September 20, 2016

To: Dr. Ronald Ballinger and other members of the Advisory Committee on Reactor Safeguards (ACRS)

Re: Short-Term Failure Risks of U.S. Thin-Wall Spent Fuel Storage Canisters

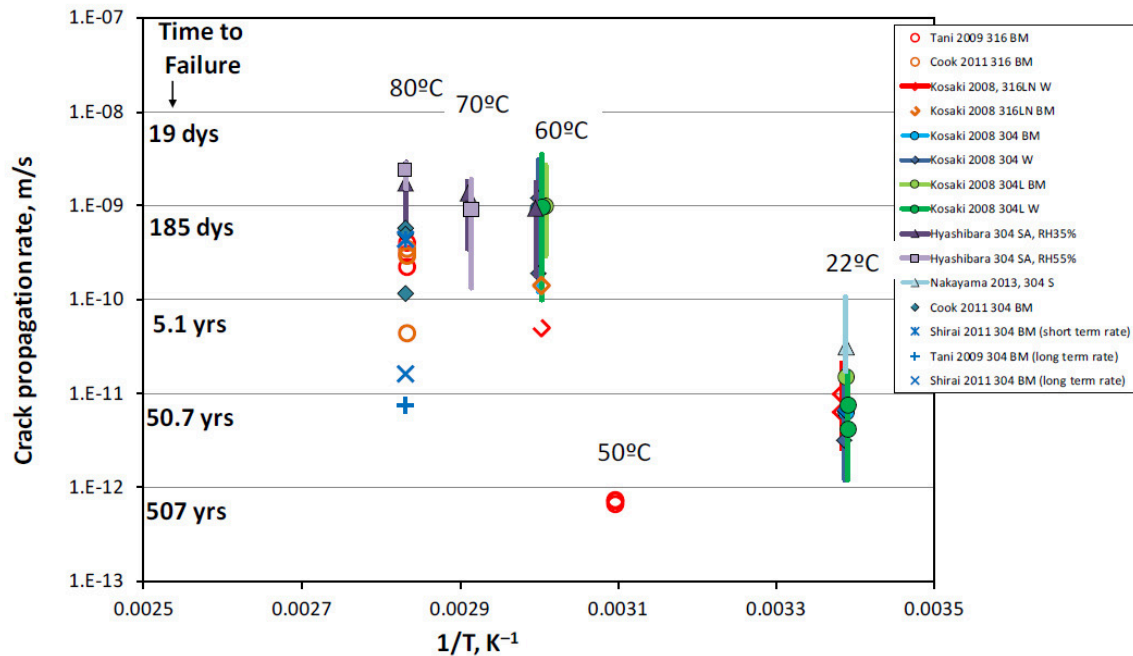
A Sandia Lab Chart shows higher temperatures can cause canisters to penetrate the wall in less than 5 years. The Chart on page 46 (and included on next page of this document) assumes canister wall is 0.625" (5/8") thick.

The majority of the U.S. canisters are only 0.50" (1/2") thick. It is unknown when a crack will start, but these canisters are subject to corrosion and cracking from numerous environment conditions such as ocean salts (chlorides), air pollution (e.g., vehicle exhaust sulfides), pitting, and microscopic scratches.
